DESIGN STANDARDS/PRACTICE EXCEPTION REQUEST SUMMARY

Title: Hwy 40:32 - Proposed Horizontal Alignment

Memorandum (or Approval) Date: August 20, 2012 Design Exception Request Date: August 14, 2012 Region: Peace Approval Status: Approved

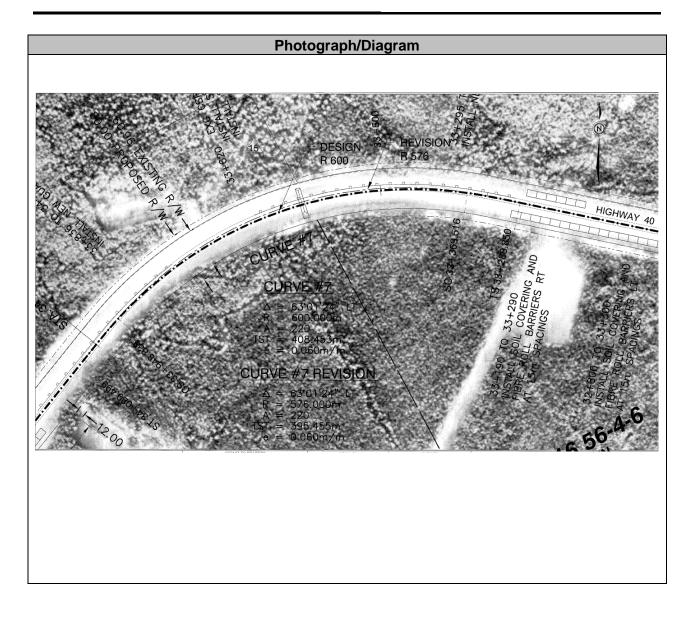
The following design exception request is for the following: Shift proposed centreline R600 m horizontal curve (Curve #7) back to existing R576 m due to groundwater and geotechnical conditions encountered during construction. Based the ATHGDG, Chapter B.3 - Horizontal Alignment, for a design speed of 110 km/h, the minimum horizontal curve is R600 m.

- Collision history for the five year period from 2006 to 2010. Safety performance is considered good. Two PDO collisions both involving single vehicle run off the road were reported. Icy road condition was reported for one of the collisions (Dec. 2007). No details of the road condition were provided for the other collision (Feb. 2008).
- The stopping sight distance of 432m for the south approach exceeds the SSD of 235 m for design speed 110 km/h.
- ISD of +500m in both directions are adequate for an existing utility access located in the vicinity of the R576m horizontal curve.

Longitudinal barriers with crashworthy end treatments will be installed as required.
